# Access Compliance Report

## Public Rights-of-Way

### (Curb Ramps)

Intersection ID: 43667	Main Street: ASHETON_CREEK_DR	Cross Street: AVEN_CREEK_CT	Location: W
ADA ID: 9E534623914E	Ramp Type: PerpDiag	Initial Pass/Fail: Fail	Overall Compliance: No
		Severity Score: 35

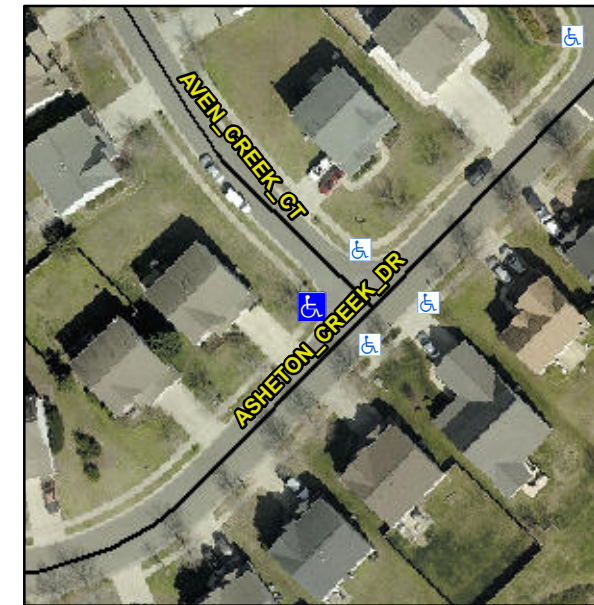
**Not Found, R304.5.1**

Compliance	Description	Data	Compliance	Description	Data
N/A	Ramp Length (in)	49.0	Yes	Ramp Slope (%)	6.5
No	Ramp Width (in)	25.0	Yes	Ramp XSlope (%)	0.8
N/A	Flare Type LT	N/A	N/A	Flare Type RT	N/A
N/A	Flare Slope LT (%)	N/A	N/A	Flare Slope RT (%)	N/A
N/A	Flare Traversable LT?	N/A	N/A	Flare Traversable RT?	N/A
N/A	Landing Length (in)	N/A	N/A	DWS Provided?	N/A
N/A	Landing Width (in)	N/A	N/A	DWS Contrast?	N/A
N/A	Landing Slope (%)	N/A	N/A	DWS Length (in)	N/A
N/A	Landing X Slope (%)	N/A	N/A	DWS Full Width?	N/A
N/A	Landing Curb? (Y/N)	N/A	N/A	DWS Offset (in)	N/A
N/A	Shared Landing?	N/A			
N/A	Gutter Ponding?	N/A	N/A	Gutter Slope (%)	N/A
N/A	Gutter Lip Ht (in)	N/A	N/A	Gutter X Slope (%)	N/A
N/A	Painted X Walk1?	No	N/A	Painted X Walk2?	No
	X Walk 1 Direction	To SE		X Walk 2 Direction	To NE
N/A	X Walk 1 Width (in)	N/A	N/A	X Walk 2 Width (in)	N/A
	X Walk 1 Slope (%)	1.7		X Walk 2 Slope (%)	1.3
	X Walk 1 X Slope (%)	2.3		X Walk 2 X Slope (%)	1.9

**Remove & Replace Curb Ramp With Two New Directional Ramps or Equivalent.**
